NUMBER 85

BULLETIN

SUBJECT: REWORKING OF BOTTOM COWL FOR REPLACING AIR SCOOP
EQ5259 WITH EQ5370 (CONTINENTAL PART NUMBERS)

MODELS AFFECTED: J3C AIRPLANES

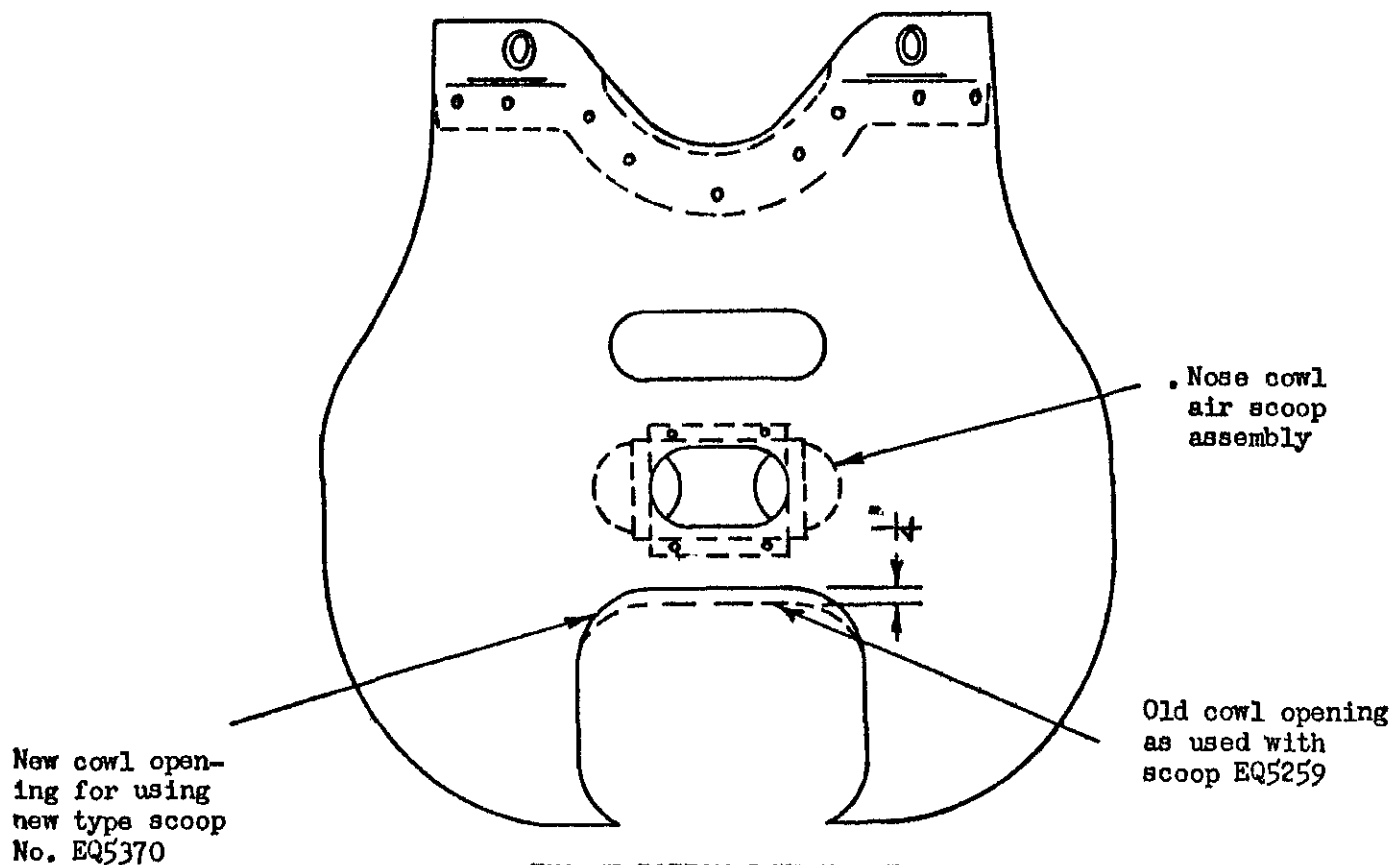
When replacing the vertical faced filter air scoop (Part No. EQ5259) with the new slant faced filter air scoop (Part No. EQ5370), the bottom cowl assembly will have to be reworked as per sketch below.
